ADDENDUM NO. 4

January 30, 2023

Three Rivers Community Schools – Three Rivers Middle School Additions and Renovation

This Addendum consists of Pages ADD 4-1 through ADD 4 - 3, Attached RFI Log, Substitution Request, and GMB Architecture and Engineering Addendum No. 4, dated January 26, 2023, consisting of 4 pages, Reissued Specification Sections; 08 71 00 – Door Hardware, 09 22 16 – Non-Structural Metal Framing, and 09 65 19 - Resilient Tile Flooring, New Sheet; S3.1E, and Reissued Sheets; G0.00, G1.01, G2.01, C8.01, A1.1E, A2.1E, A2.30, A5.01, A6.01, A7.03, A8.01, A8.02, M1.1D, M1.1E, M1.81, M2.1C, M2.1D, M2.1E, M3.1D, M8.01, M8.03, M8.04, M9.01, M9.02, E1.1C, E1.1D, E2.1D, E2.1E, and E7.01.

UNIT 'D' MECHANICAL DEMOLITION PLAN
1/8" = 1'-0"

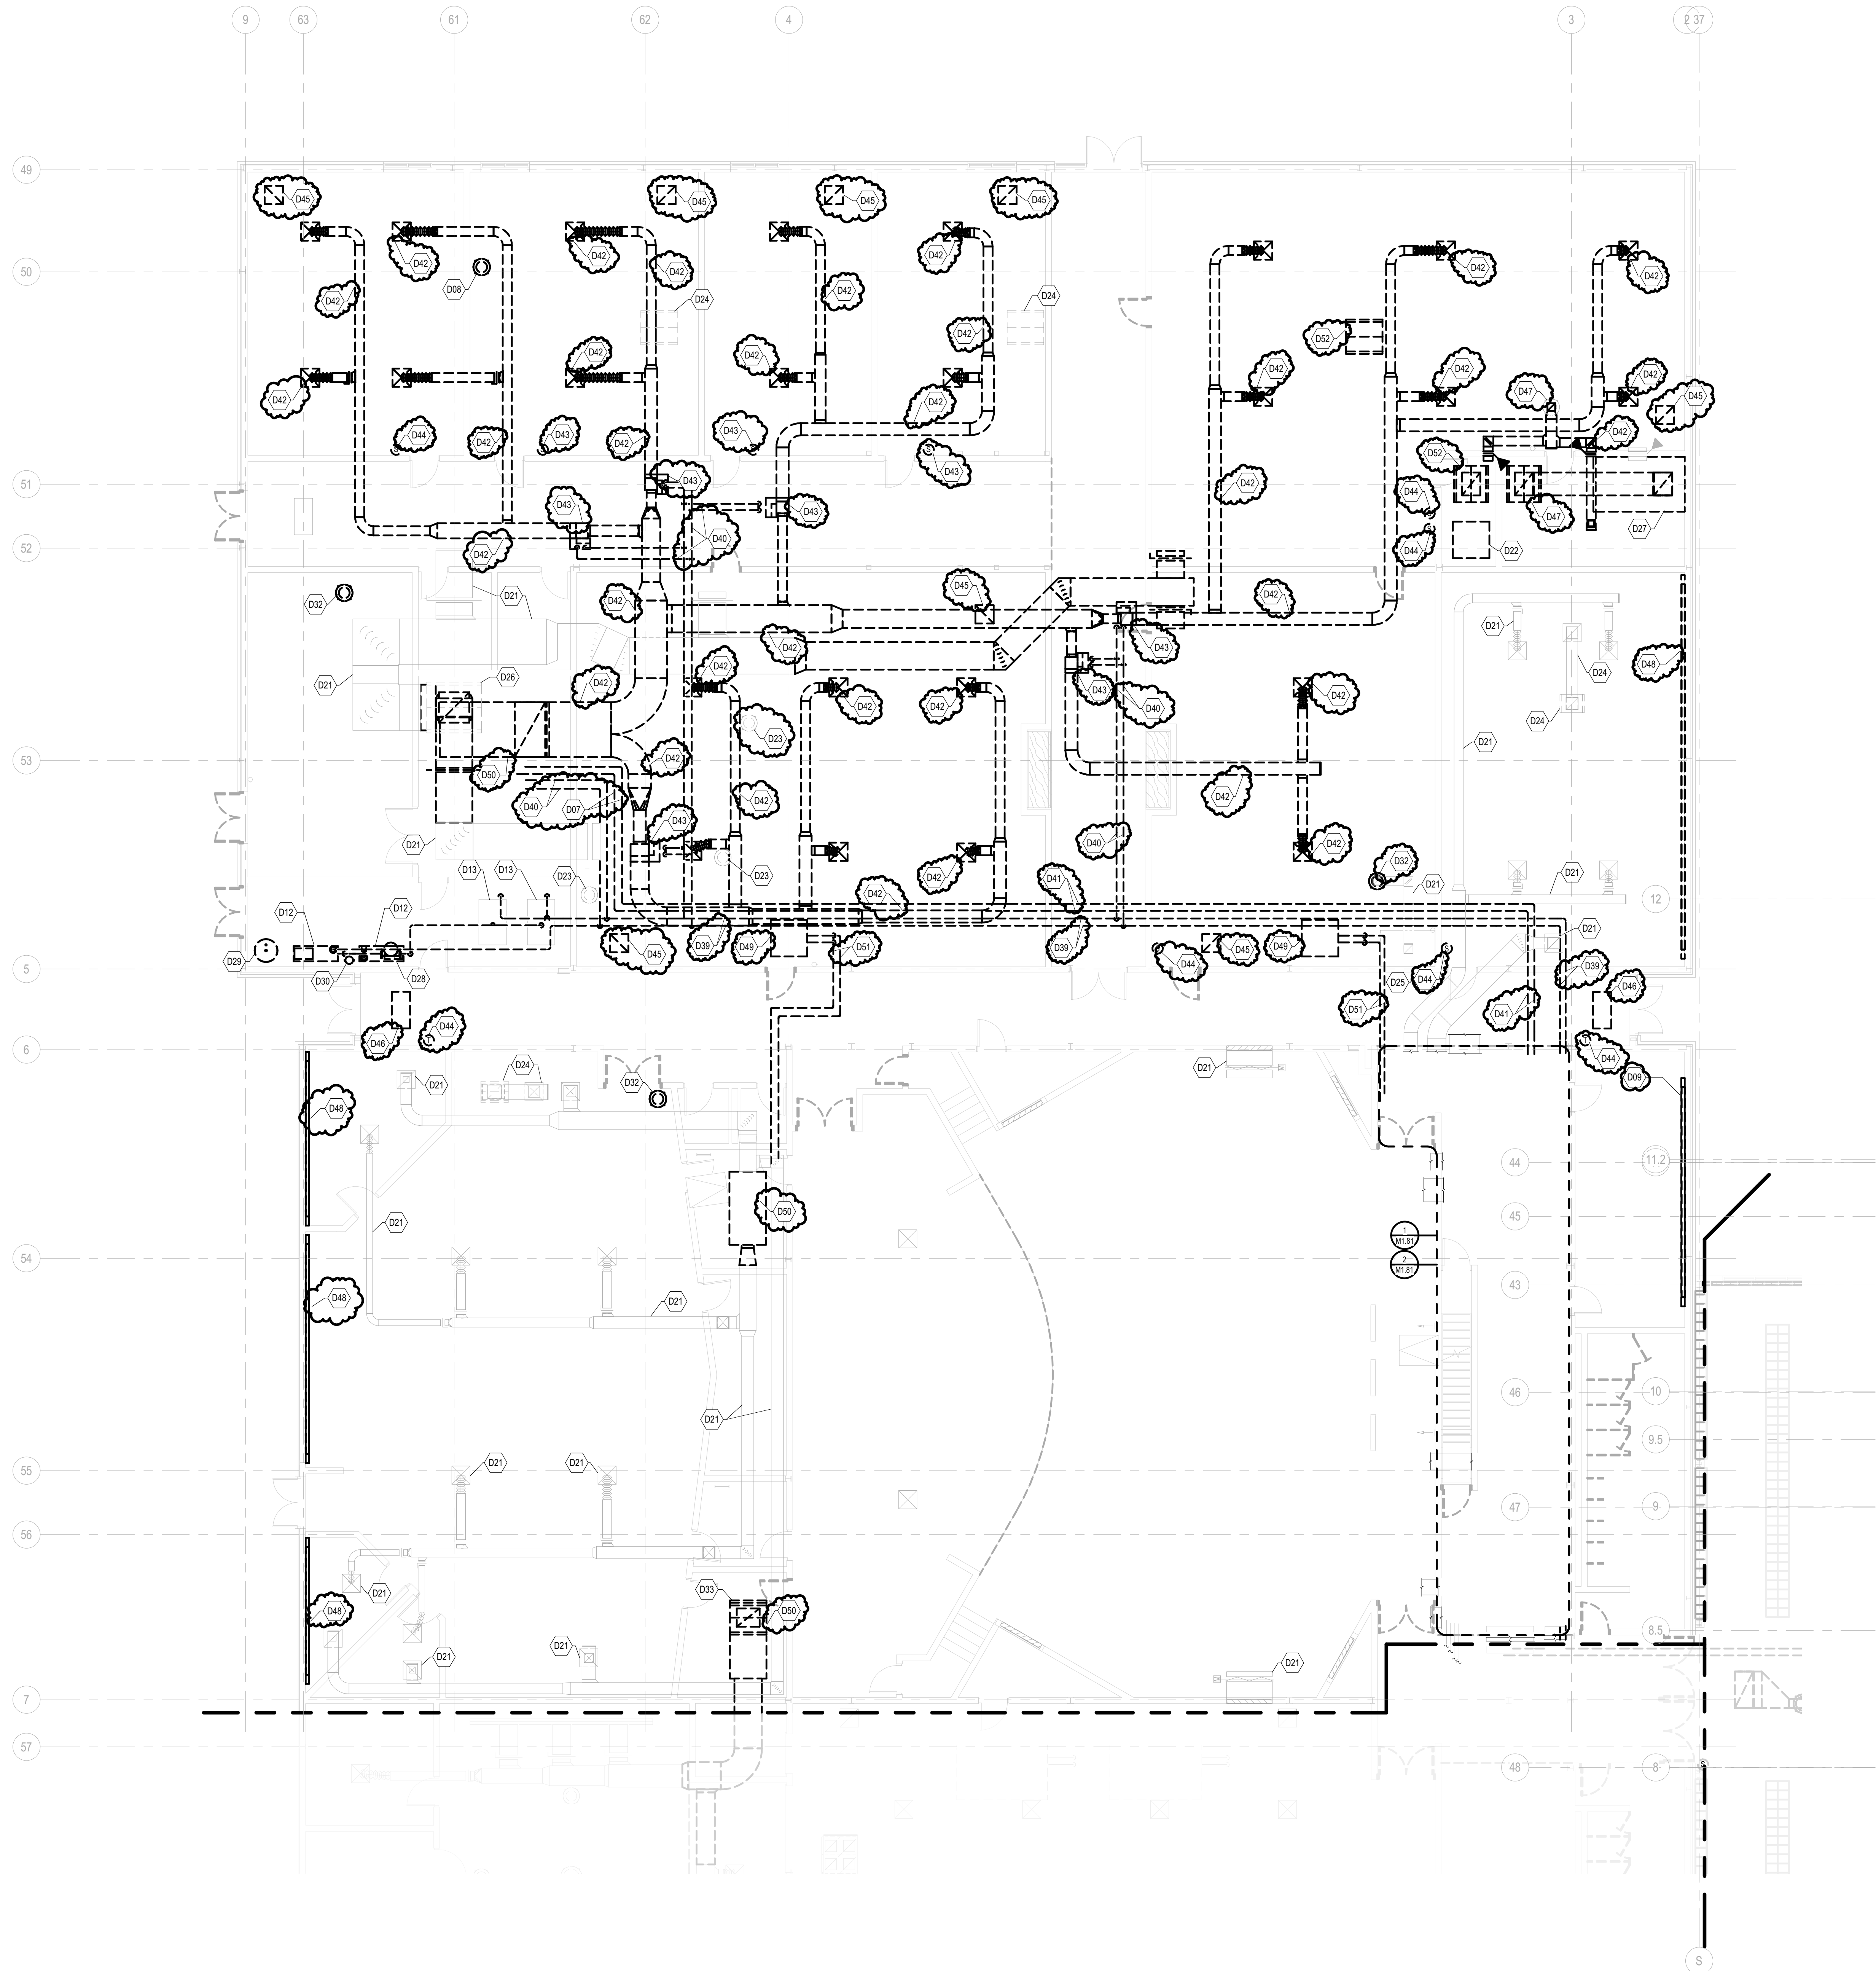
- A. Added and revised mechanical demolition keynotes.
- B. Revised Mechanical Demo Keynote Legend.

UNIT 'E' MECHANICAL DEMOLITION PLAN
1/8" = 1'-0"

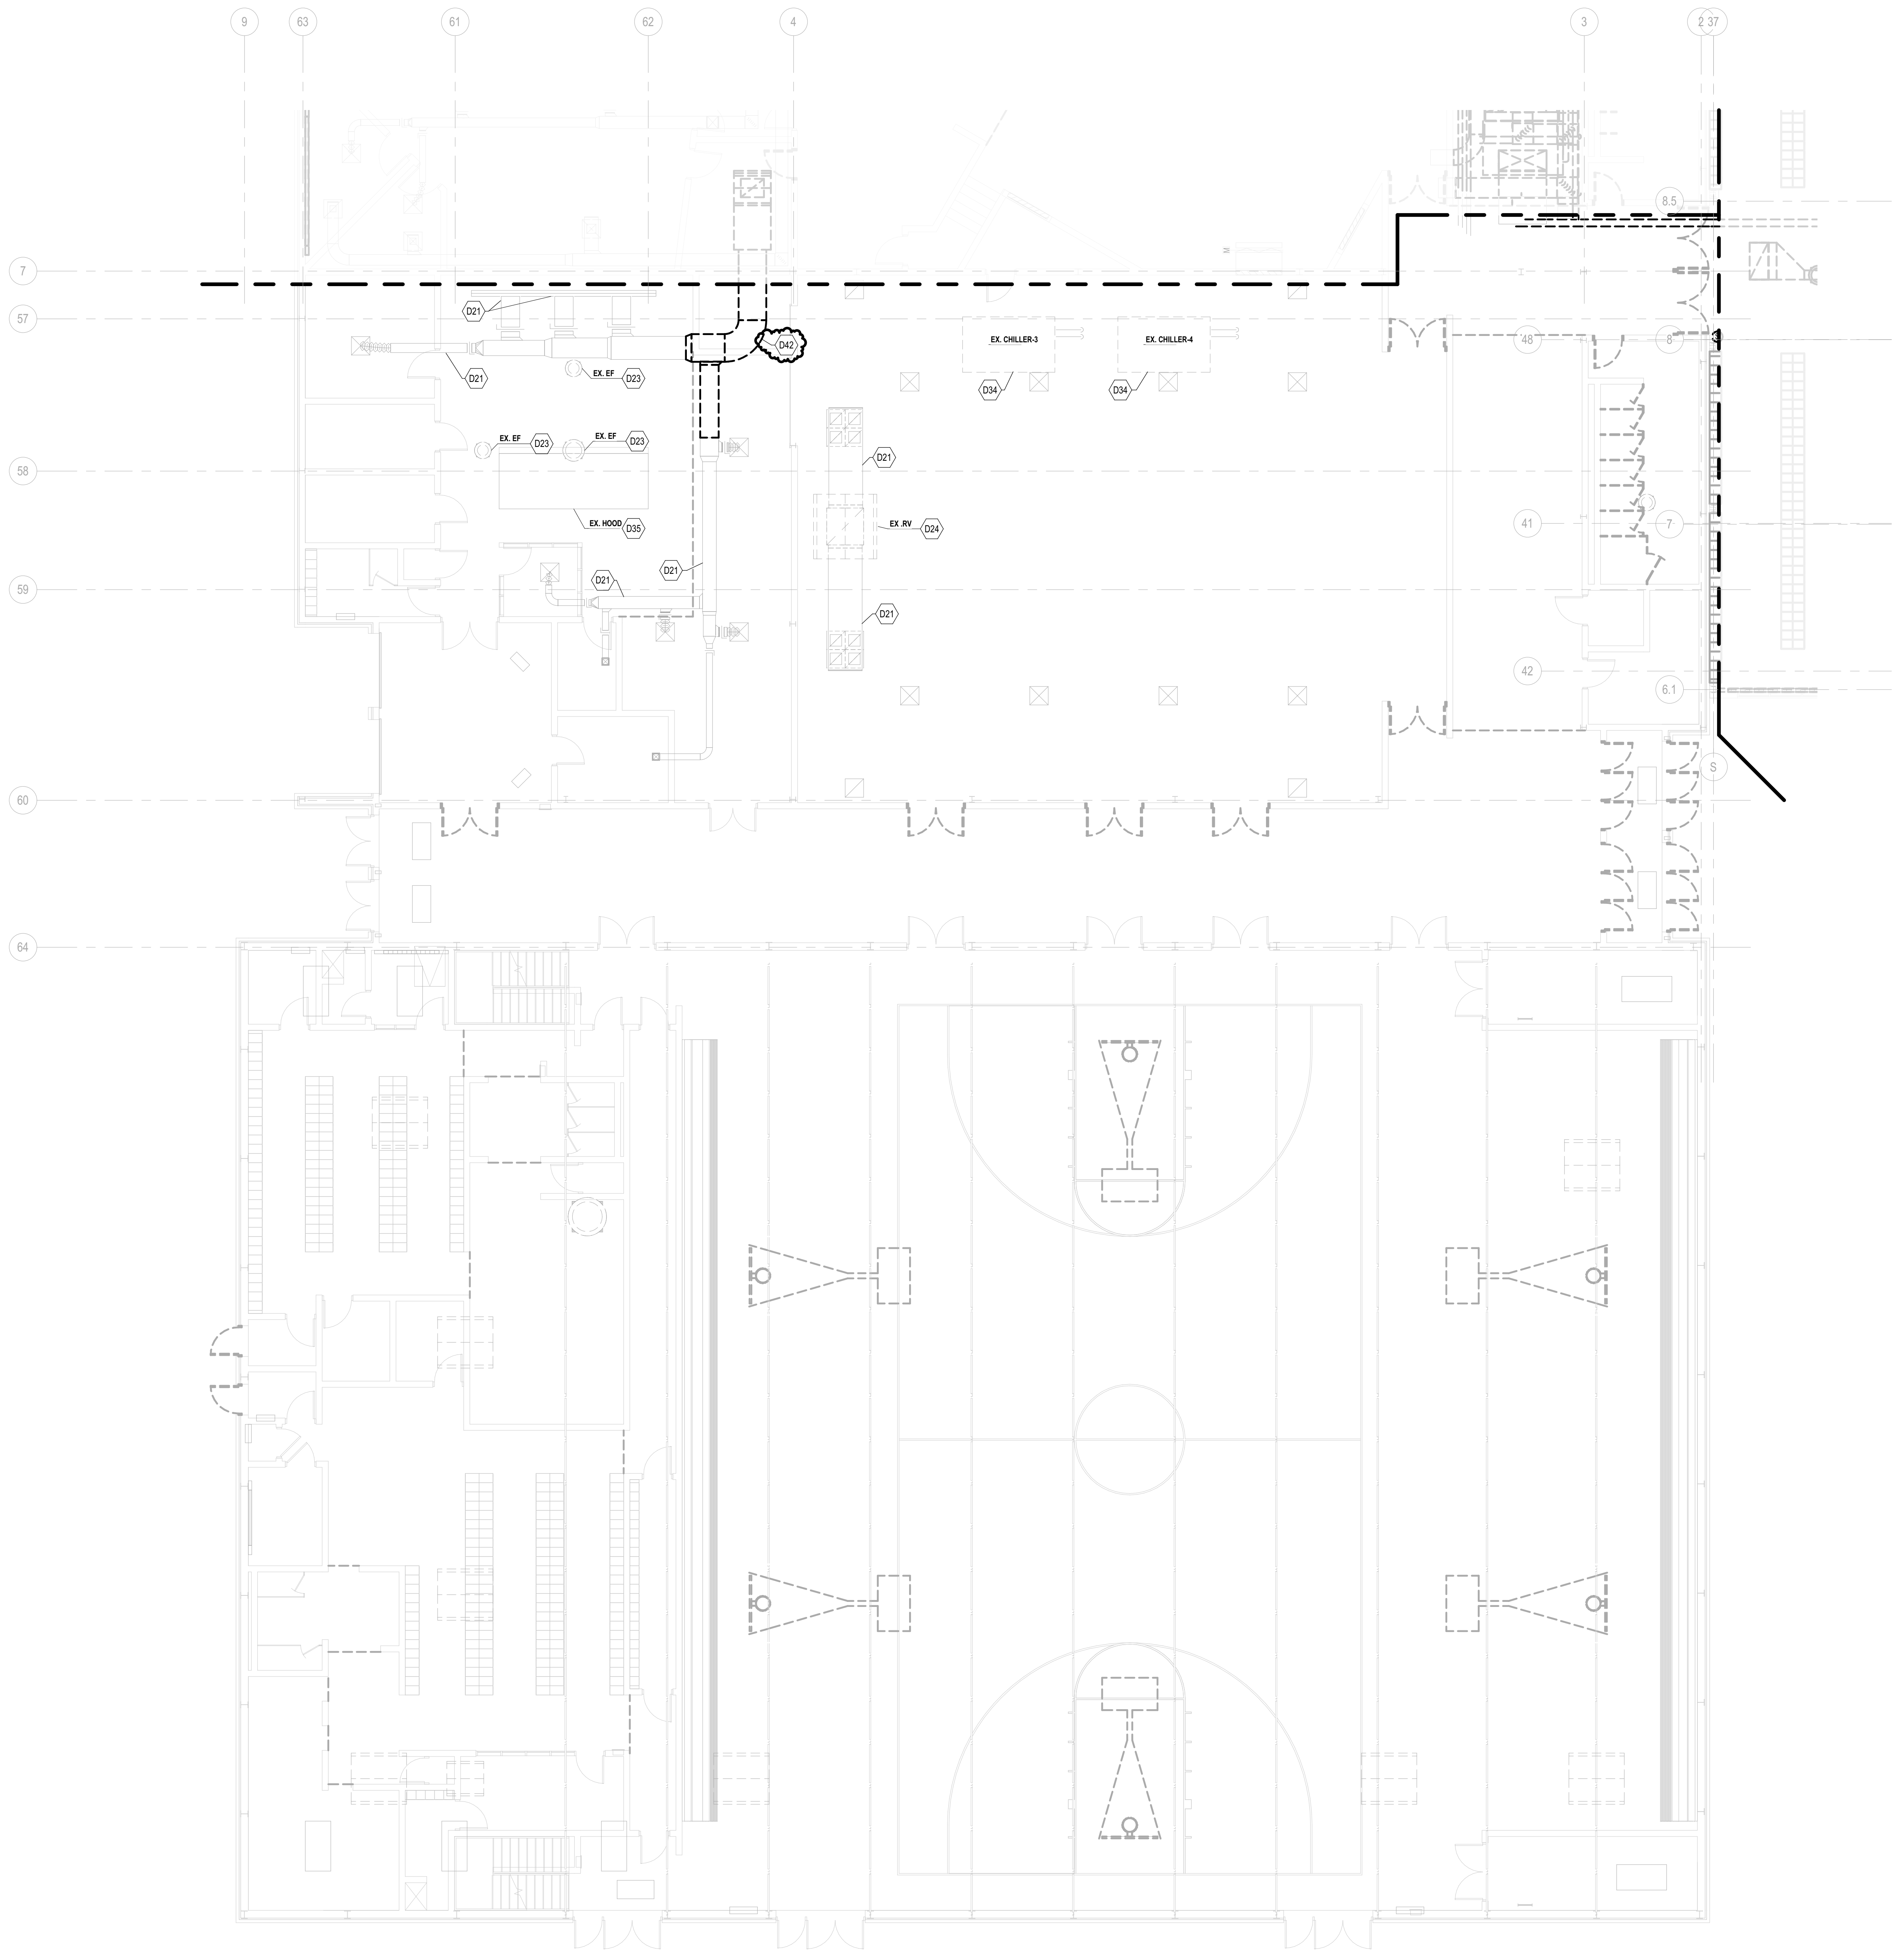
- A. Added mechanical demolition keynotes.
- B. Revised Mechanical Demo Keynote Legend.
